工程指示 / 要求簡箋(E.I.)

工程指示編號：EI / 1118 / 19 修改版次：A
 工程編號：J - 837 工程名稱：觀塘裕民坊
 工程項目：天面百葉拆圖
 收件人：生統 / 永林 發件人：Bessie Lau

日期：05/11/2019

TITLE :
 FULL PLAN LAYOUT
 (FOR T1 INTERMEDIATE ROOF)

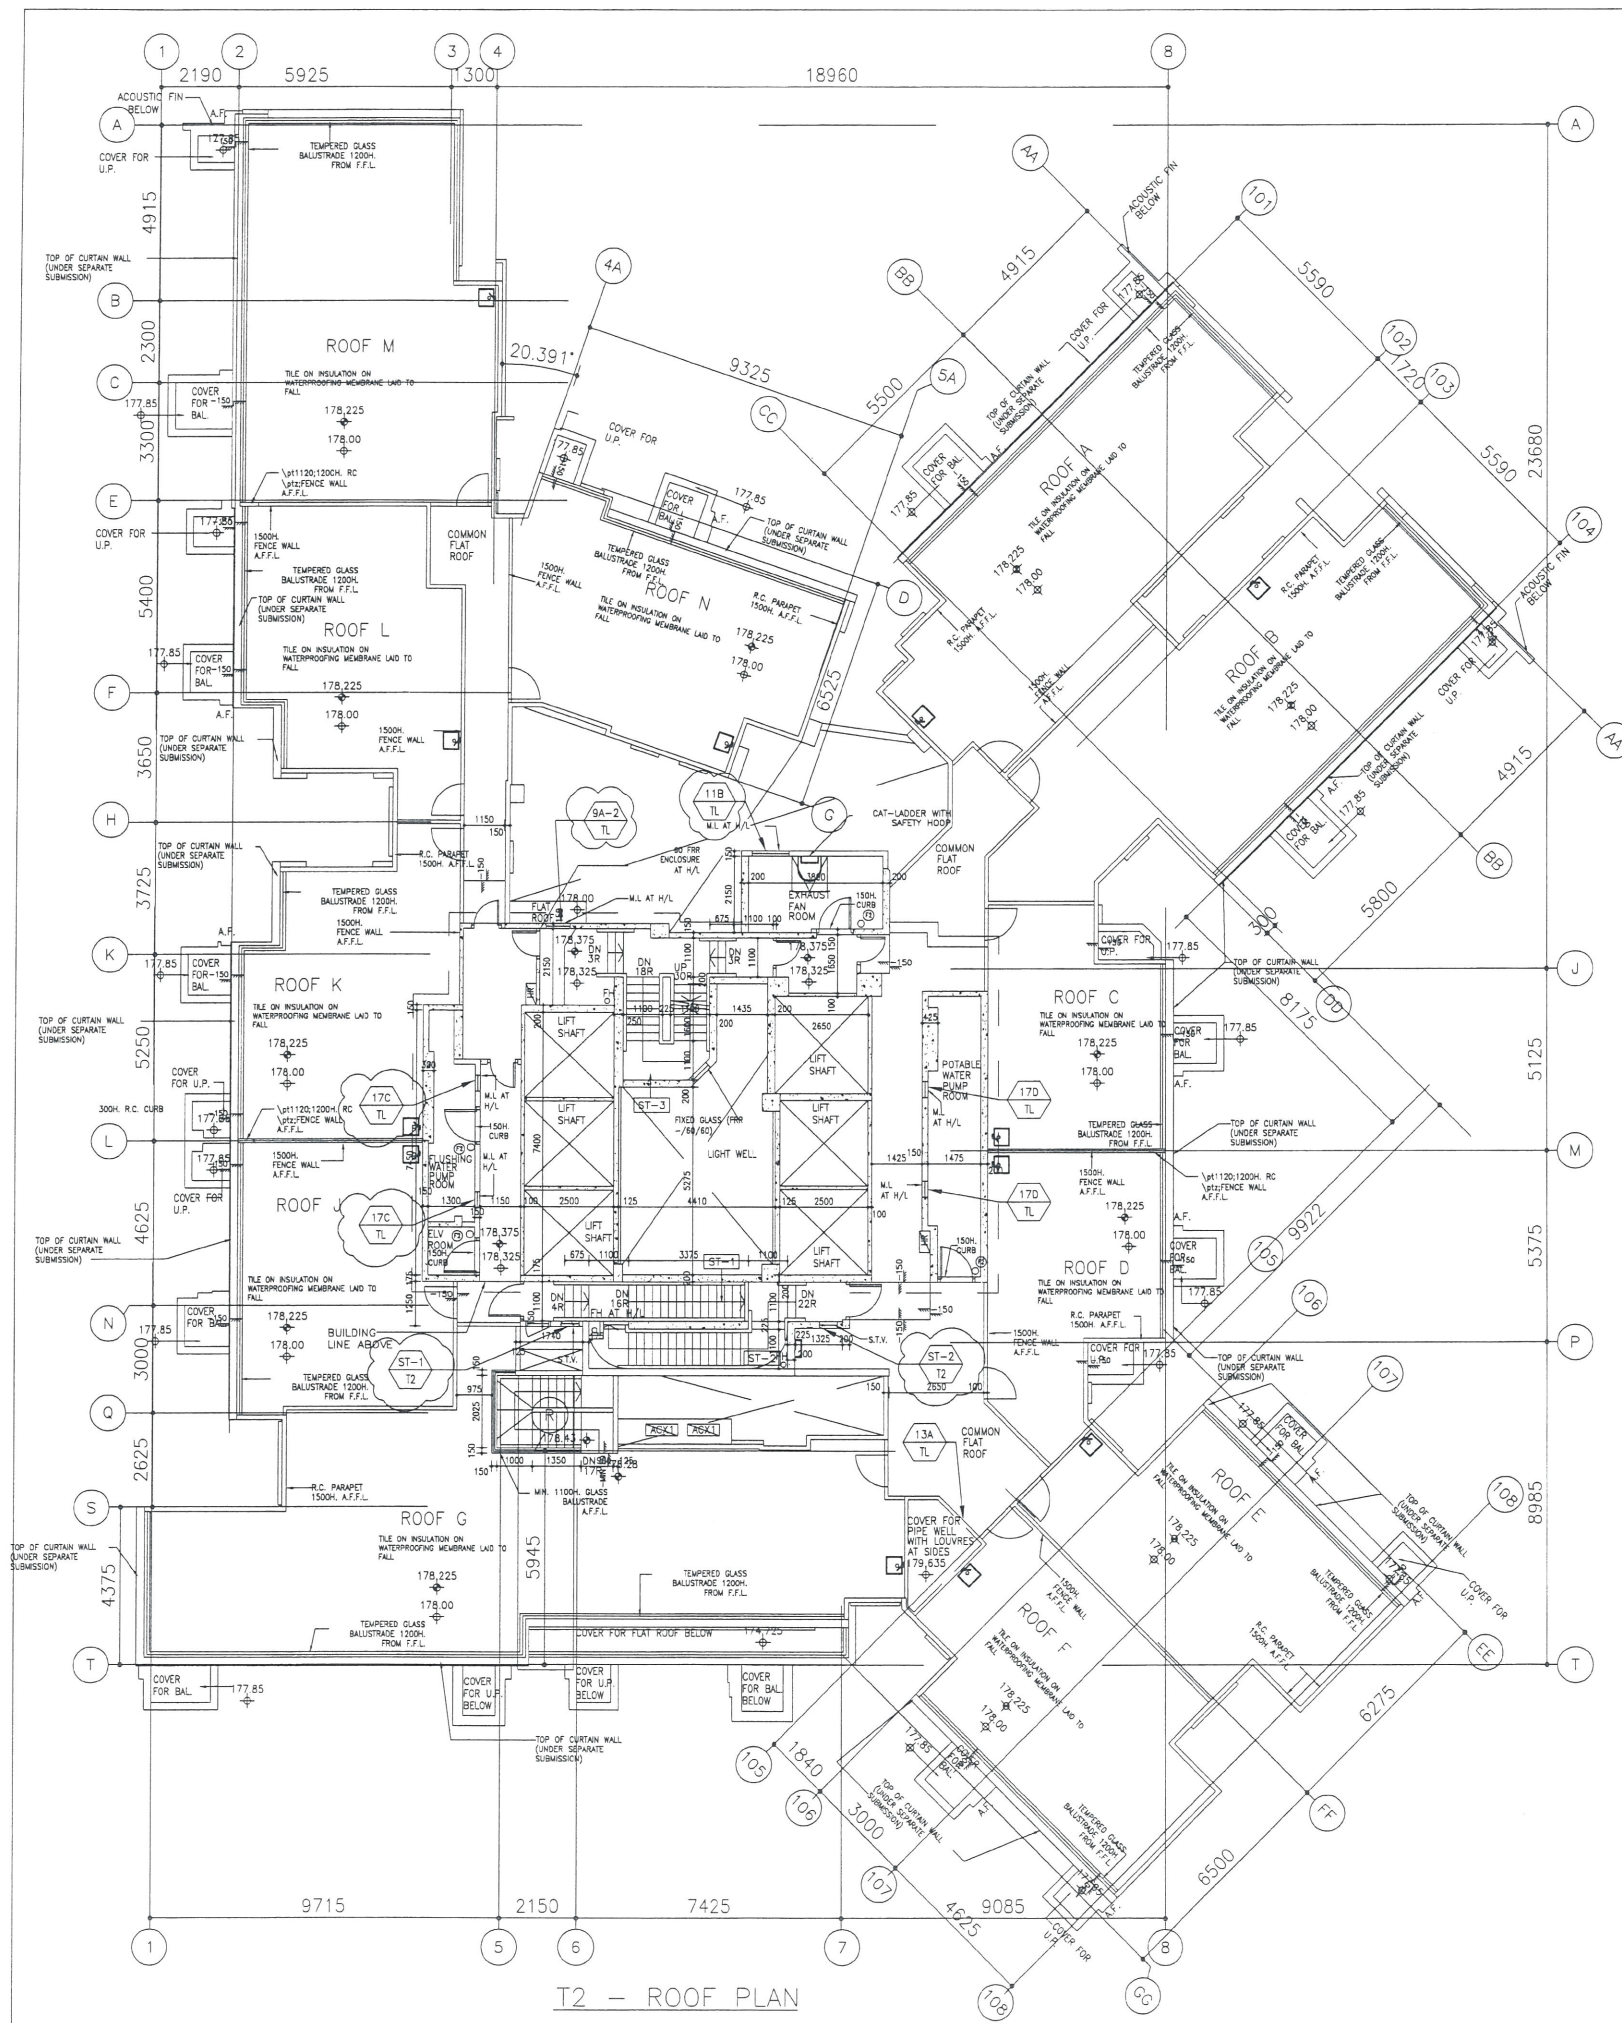
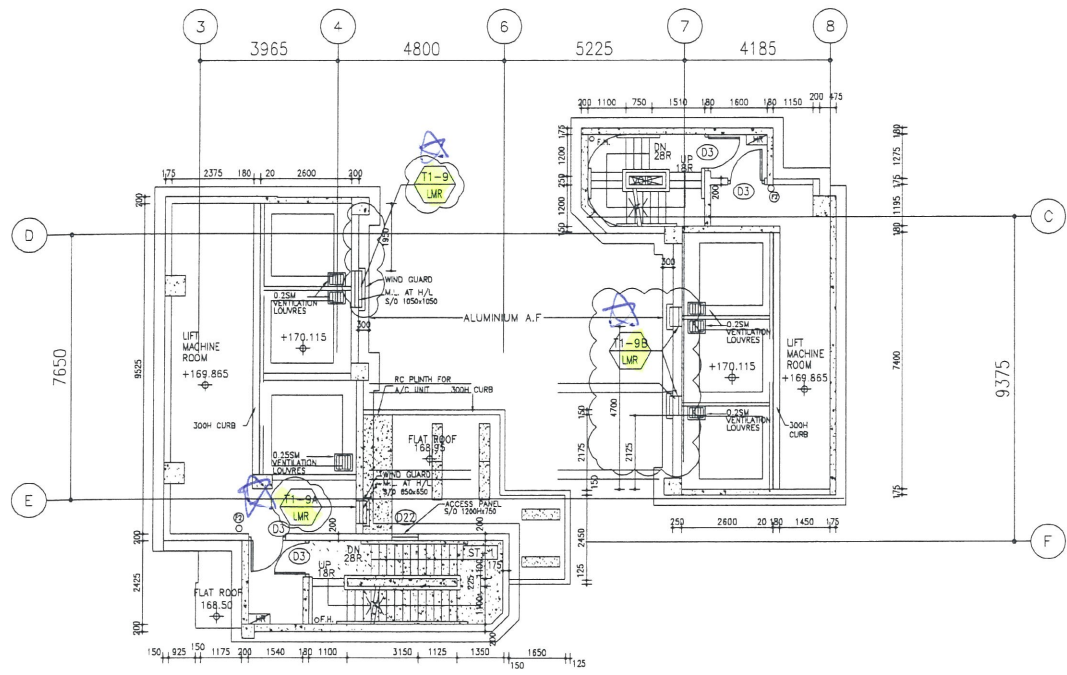
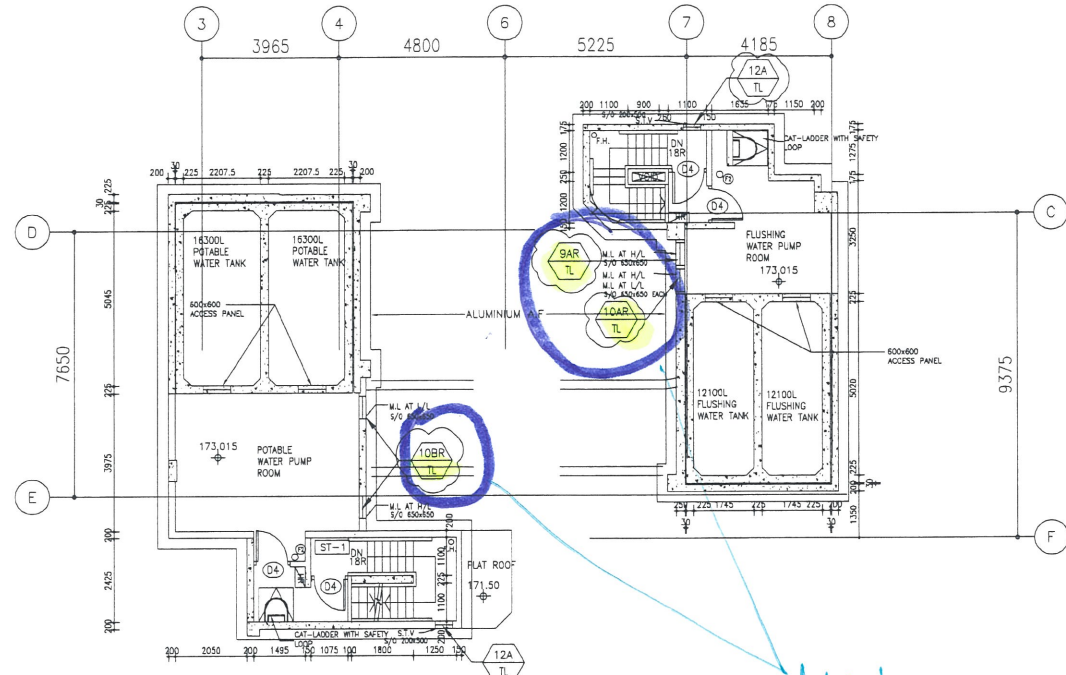
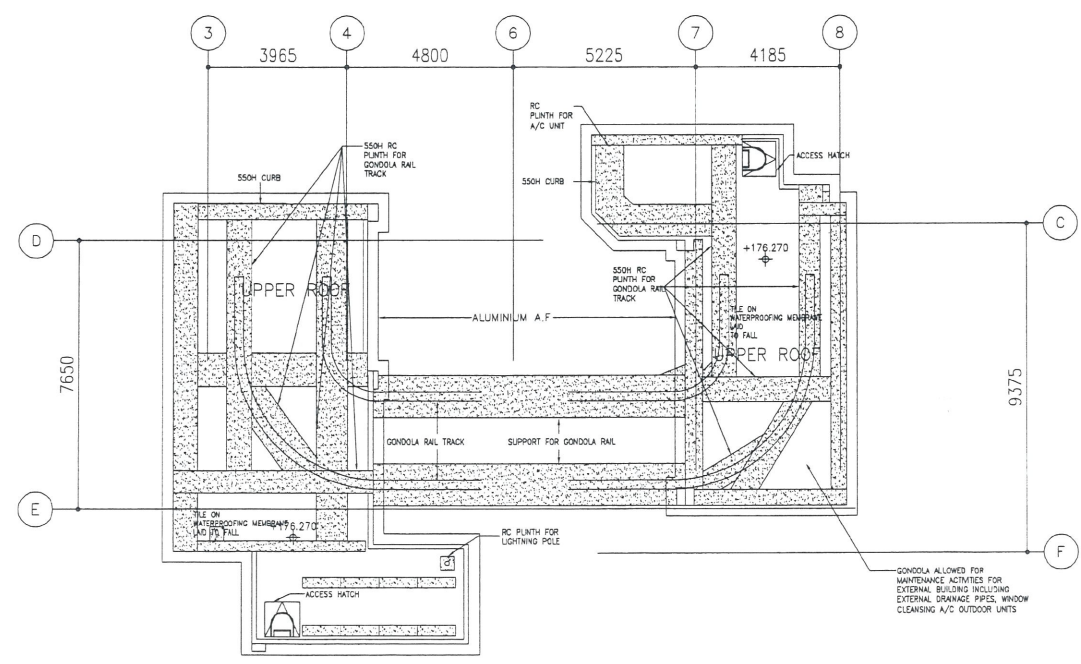
關於附件圈起的天面百葉，則師已於 2019 年 10 月 9 日的 RFI MEETING 批核，煩請按此提供拆圖，另請留意要裝雀仔網(大樣有標示要裝雀仔網，用 J837 平台餘料，即 EI0029/19 訂購過的鉛水雀仔網 6x6mm 方格，黑色油漆)，謝謝！

另請提供每幅百葉的雀仔網尺寸以供訂料用。

☆ = 已拆

○ = 未拆 (请提供拆图)
